# CITY OF ALBUQUERQUE

**RE: Pino Periodontics  
7413 Holly Ave. NE  
Grading & Drainage Plan  
Engineer's Stamp Date: 04/21/21  
Hydrology File: C19D068**

Based upon the information provided in your submittal received 04/22/2021, the Grading & Drainage Plan **is not** approved for Building Permit. The following comments need to be addressed for approval of the above referenced project:

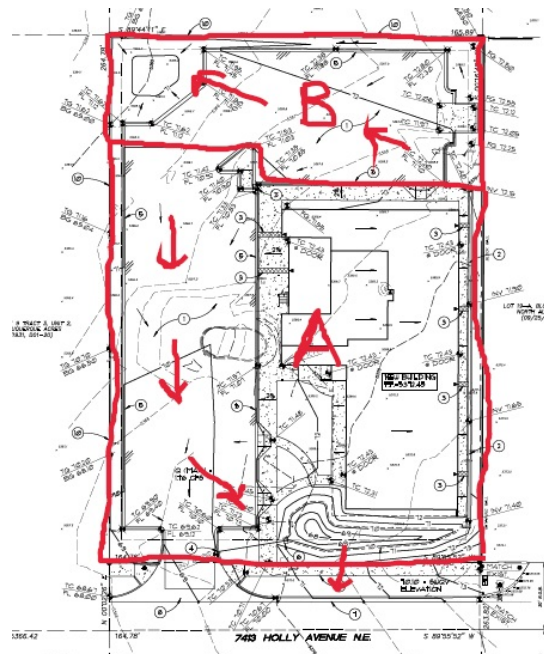
1. It appears that the site has two drainage areas. (See below) Therefore, please separate these two in the Proposed calculations as two separate areas. I just called them "A" & "B". It looks like "A" will drain through the SWQ pond and discharge the allowable discharge of 2.01 cfs into Holly. "B" looks like it will drain into a retention pond.

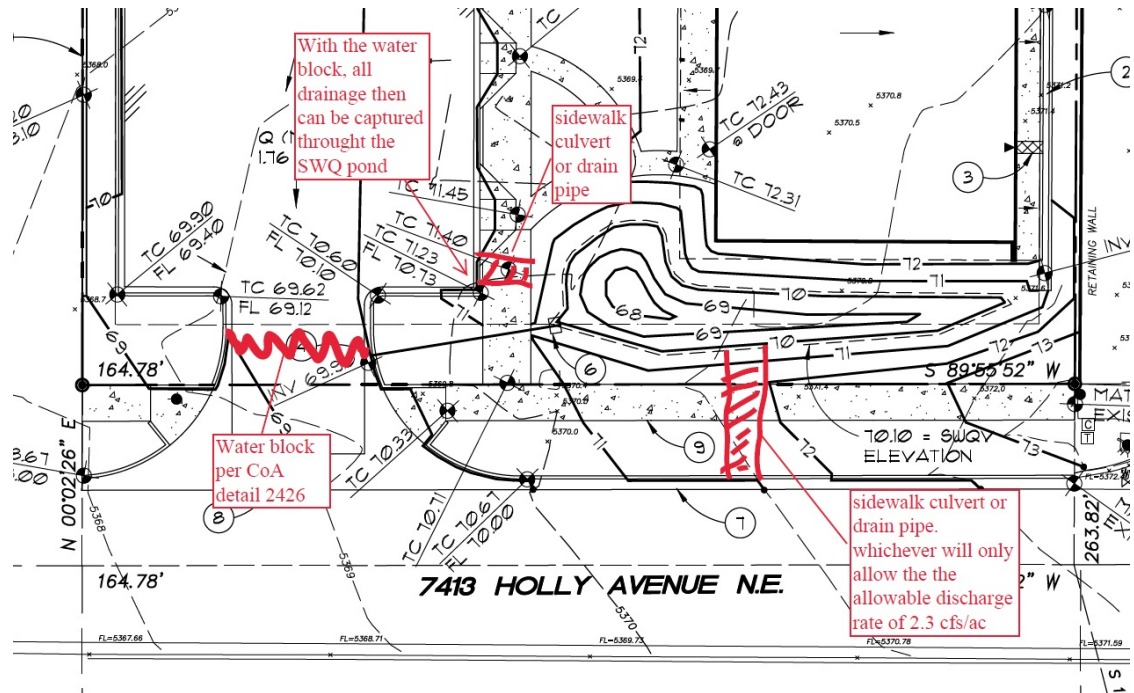
2. A water block, 0.87' high, per COA Paving Detail No. 2426, is required at the driveway entrance. With this water block, the drainage from Area "A" will drain through the SWQ pond and discharge the allowable discharge of 2.01 cfs into Holly.
